## **ADDENDUM NO. 1**

**PROJECT NAME: *Grand Ridge Fire Station***

**PROJECT NUMBER: *FLORIDA COMMERCE: CDBG MT147***  
***DHM PROJECT NUMBER: GRD22MT***

**GRAND RIDGE FIRE DEPARTMENT  
ARCHITECTURAL ADDENDUM  
November 12, 2025**

**A-5.1**

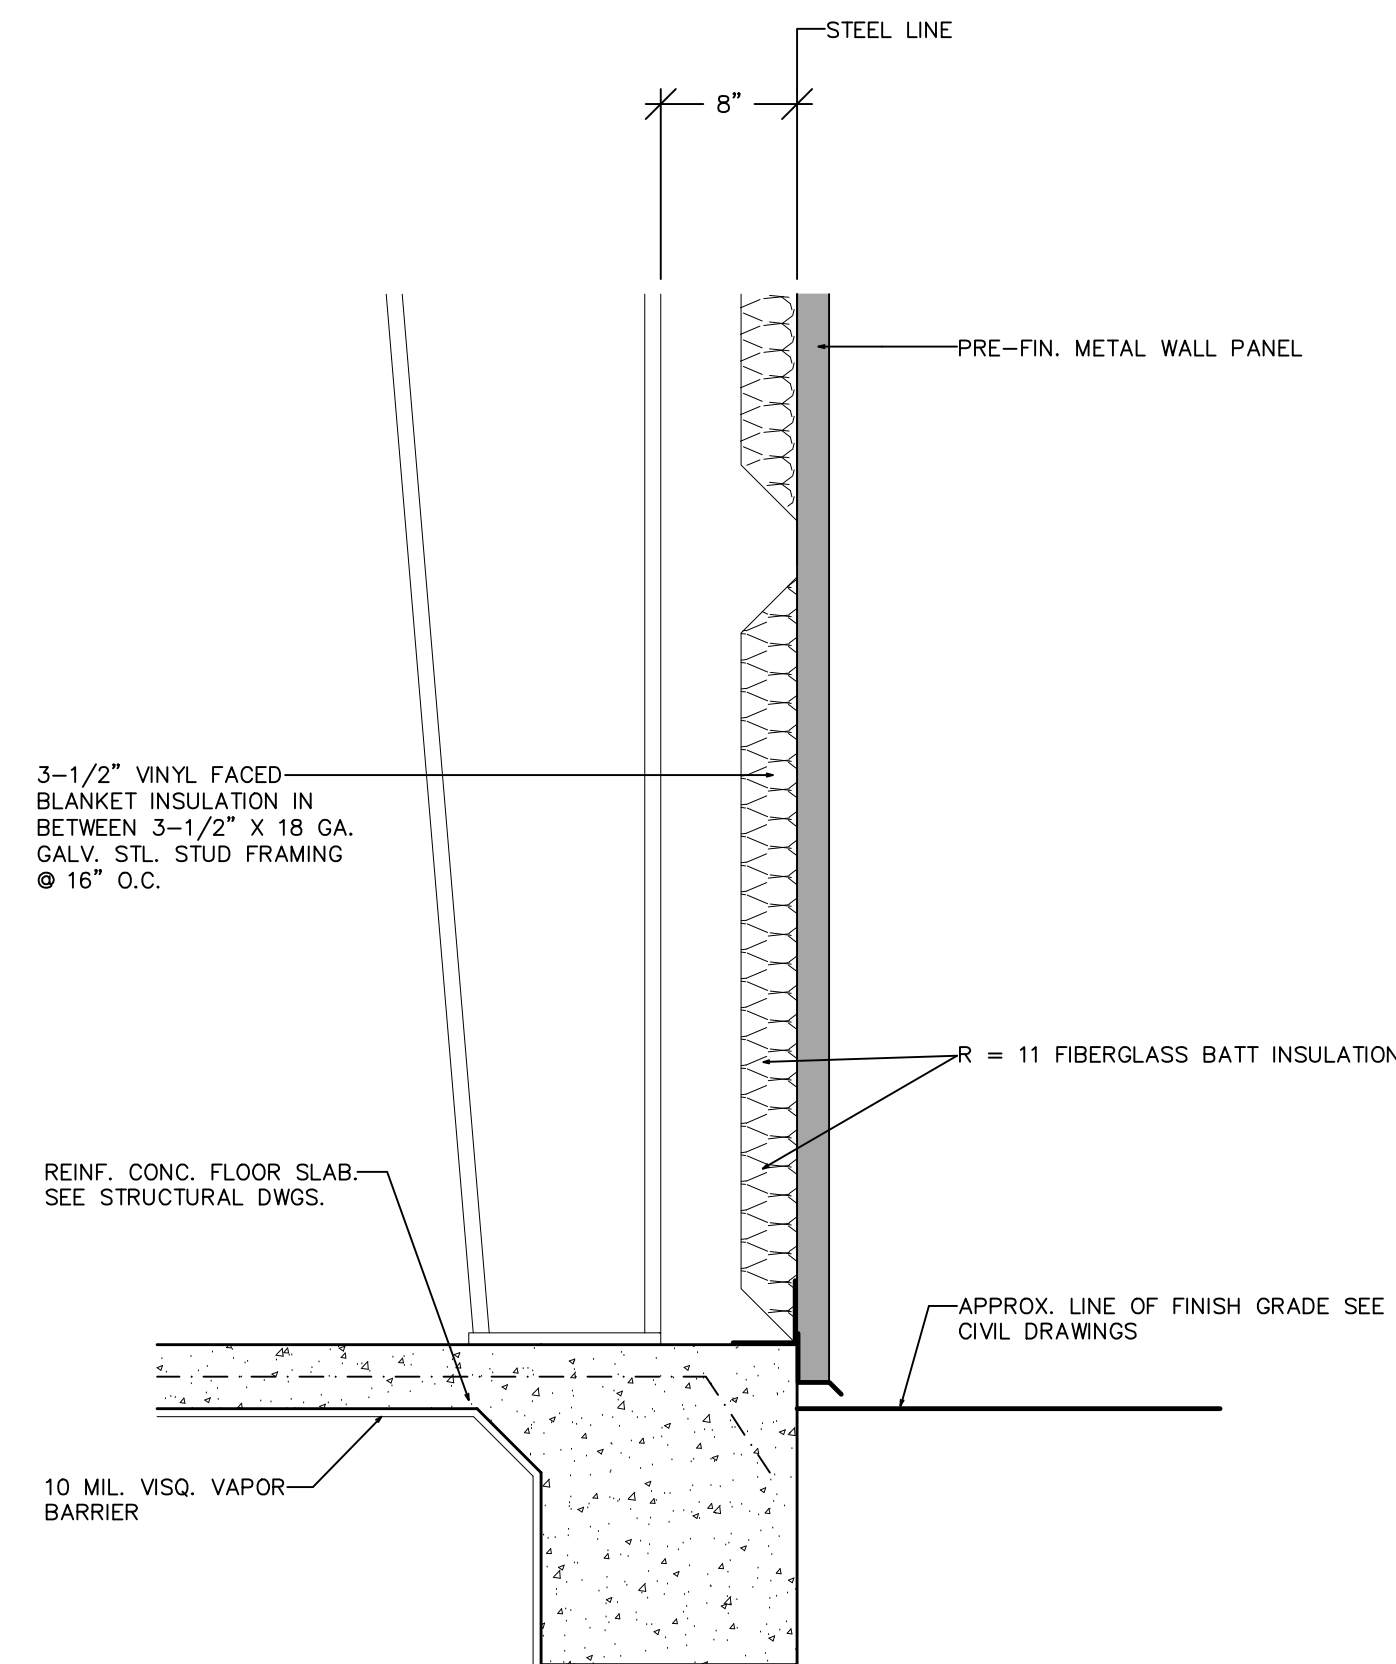
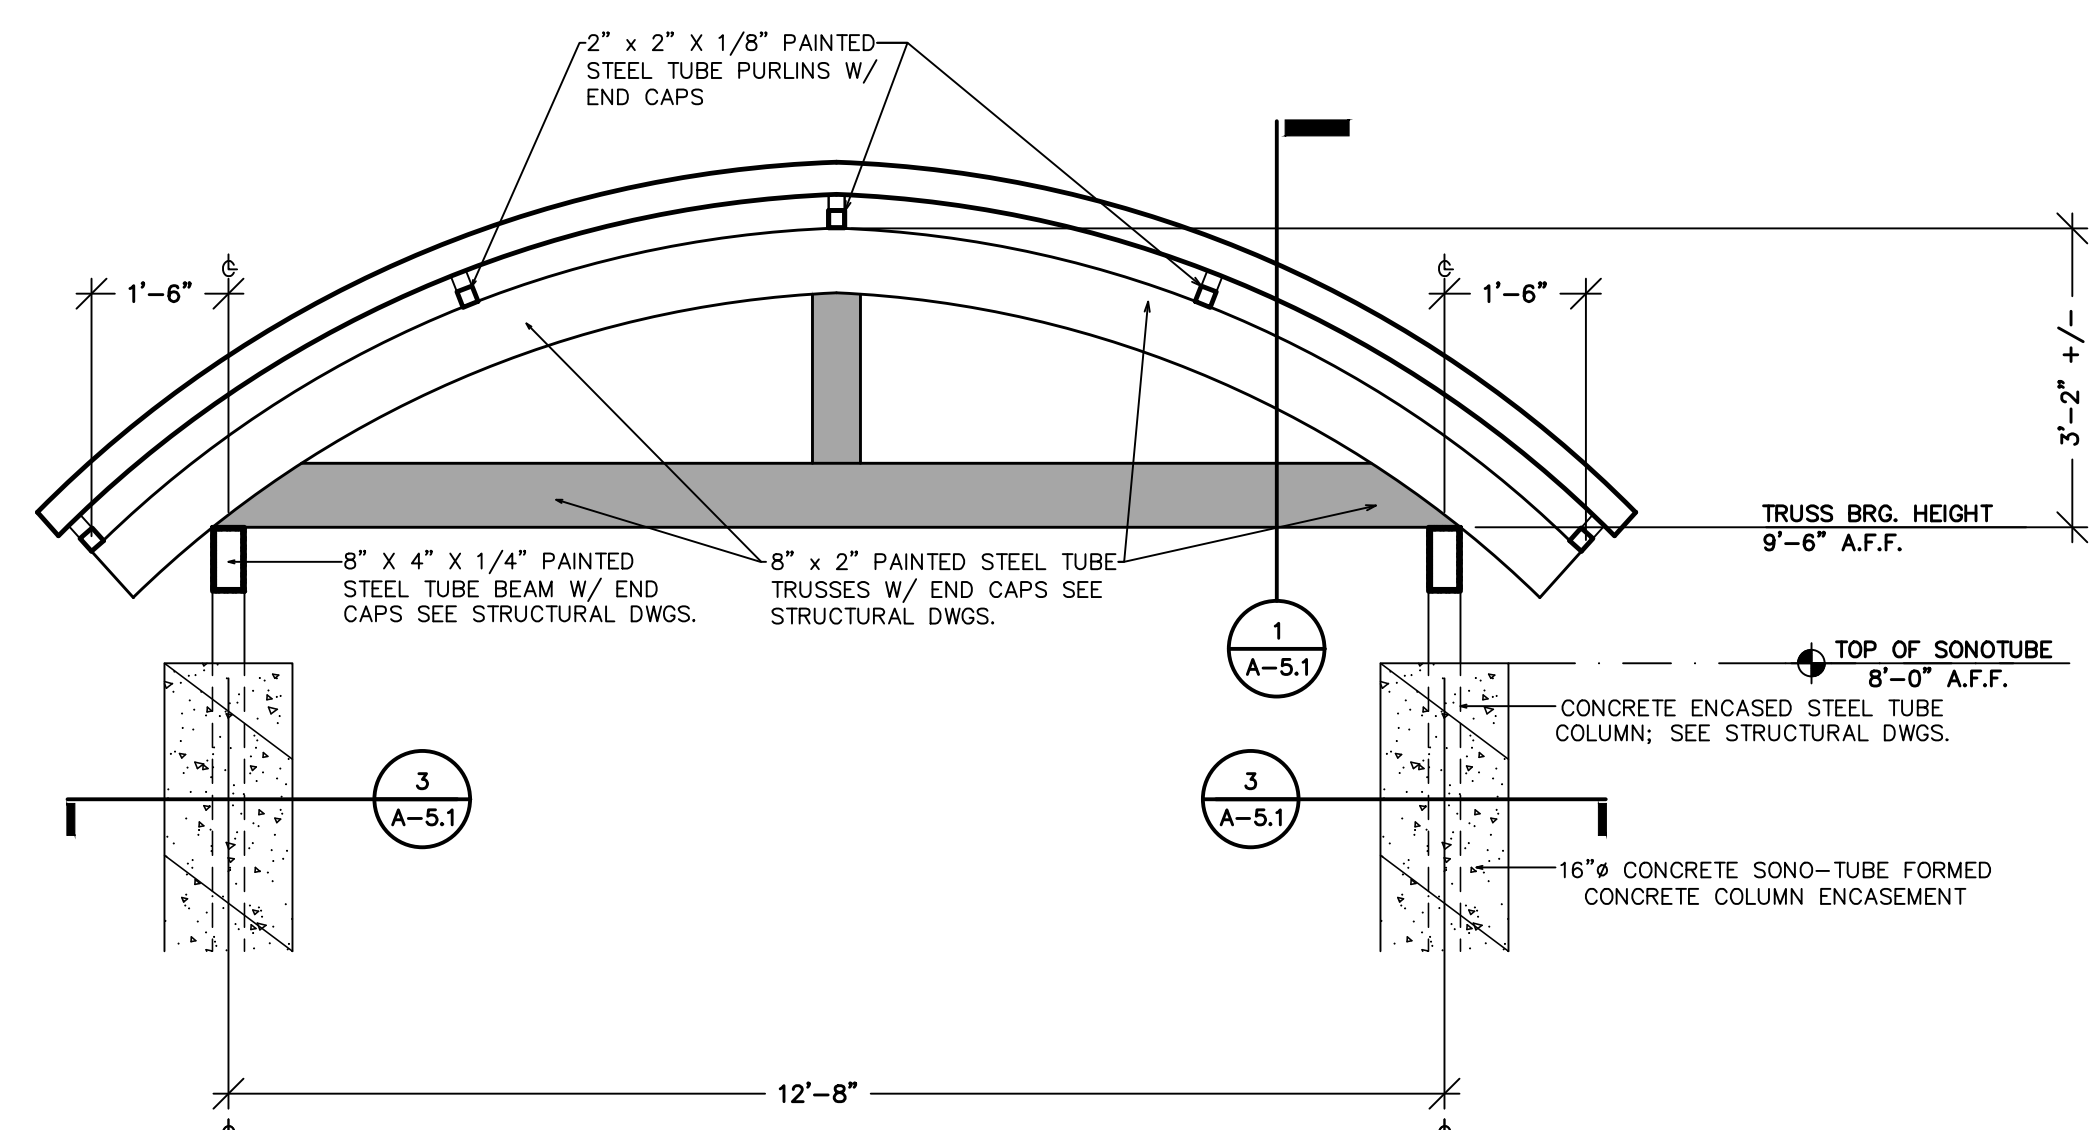
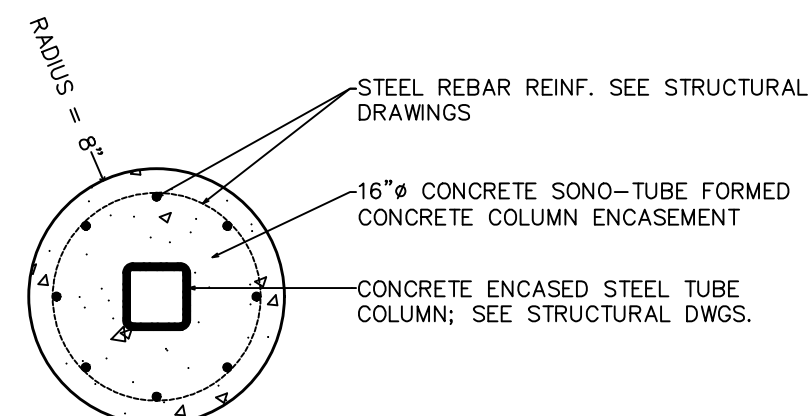
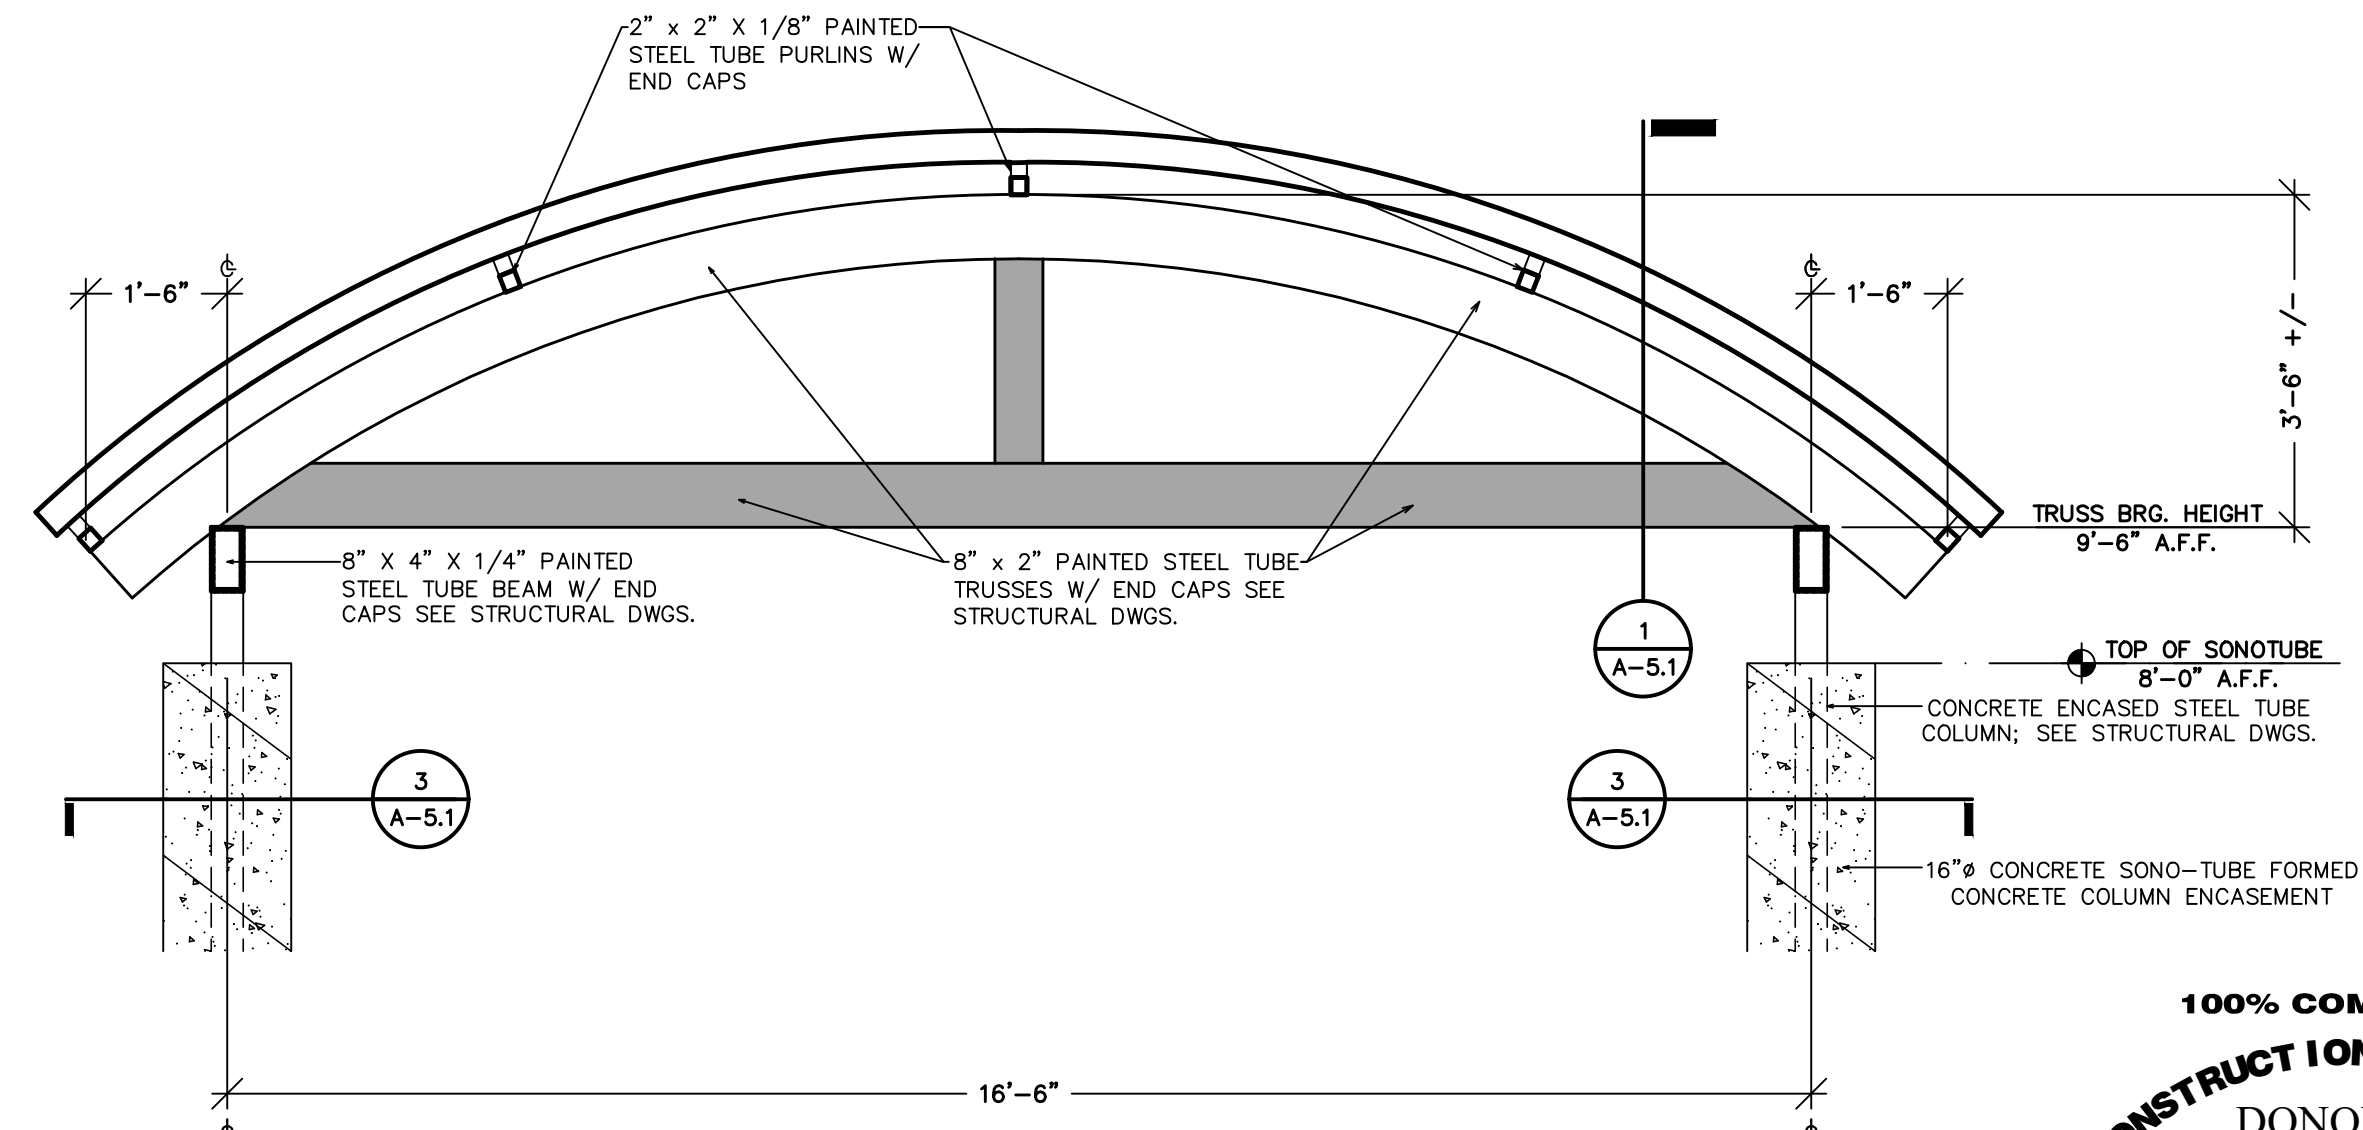
| <b>Item 6:</b><br>11-12-2025 | <b>Drawings, Sheet A-5.0 and A-5.1, Transverse Building Section 1/A-5.0 and Section 1/A-5.1, See Revised Sheets A-5.0 and A-5.1, included with this addendum</b><br><br><b>Revision</b> – Required roof insulation assembly over rooms 101 and 112.                                           |
